# Access Compliance Report

## Public Rights-of-Way

Intersection ID: 22962	Main Street: DEER_TRAIL_LN	Cross Street: HUNTERS_LANDING_DR	Location: SW
ADA ID: E860CB25730C	Ramp Type: Perp	Initial Pass/Fail: Fail	Overall Compliance: No
		Severity Score: 8.75

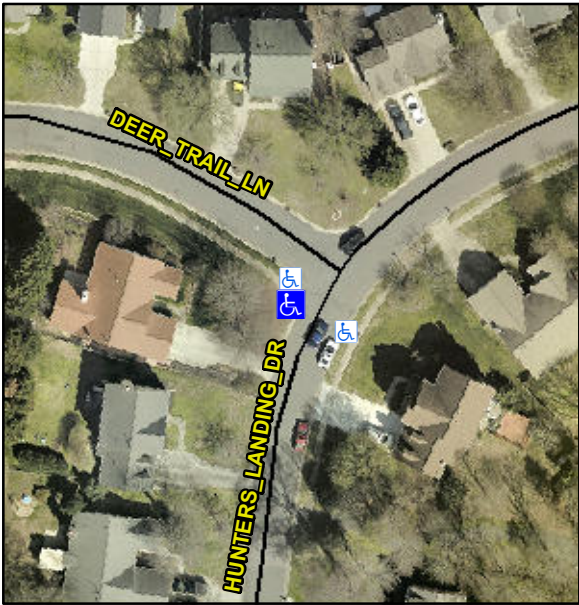
Codes/Mitigation Info/Possible Solution				Field Measurements/Component Compliance					
	Possible Solutions:			Compliance	Description	Data	Compliance	Description	Data
	Remove & Replace Entire Ramp.			N/A	Ramp Length (in)	96.0	Yes	Ramp Slope (%)	6.8
				No	Ramp Width (in)	45.0	Yes	Ramp XSlope (%)	0.1
				N/A	Flare Type LT	N/A	N/A	Flare Type RT	N/A
				N/A	Flare Slope LT (%)	N/A	N/A	Flare Slope RT (%)	N/A
				N/A	Flare Traversable LT?	N/A	N/A	Flare Traversable RT?	N/A
				N/A	Landing Length (in)	N/A	N/A	DWS Provided?	N/A
				N/A	Landing Width (in)	N/A	N/A	DWS Contrast?	N/A
				N/A	Landing Slope (%)	N/A	N/A	DWS Length (in)	N/A
				N/A	Landing X Slope (%)	N/A	N/A	DWS Full Width?	N/A
Surveyor Notes:			N/A	N/A	Landing Curb? (Y/N)	N/A	N/A	DWS Offset (in)	N/A
PROW/ADA:			R304.5.1	N/A	Shared Landing?	N/A			
				N/A	Gutter Ponding?	N/A	N/A	Gutter Slope (%)	N/A
				N/A	Gutter Lip Ht (in)	N/A	N/A	Gutter X Slope (%)	N/A

N/A	Painted X Walk1?	No	N/A	Painted X Walk2?	N/A
					X Walk 1 Direction	To SE		X Walk 2 Direction	N/A
				N/A	X Walk 1 Width (in)	N/A	N/A	X Walk 2 Width (in)	N/A
					X Walk 1 Slope (%)	5.1		X Walk 2 Slope (%)	N/A
					X Walk 1 X Slope (%)	1.5		X Walk 2 X Slope (%)	N/A
Street 1 Name			HUNTERS LANDING DR	N/A	Ramp inside XWalk1?	N/A	N/A	Ramp inside XWalk2?	N/A
Stop Condition-Street 2			None		Road Slope (%)	N/A	N/A	Clear Space?	N/A
Street 2 Name			N/A		Road X Slope (%)	N/A	N/A	Clear Space to XWalk (in)	N/A
Stop Condition-Street 1			N/A	N/A	Any Obstructions?	N/A	N/A	Storm Grate/Utility Hazard?	N/A
					Obstruction Type			Storm Grate/Utility Type	
						N/A			N/A
							Yes	Surface Condition? (G/P)	Good
Total Cost:			\$ 1850.00
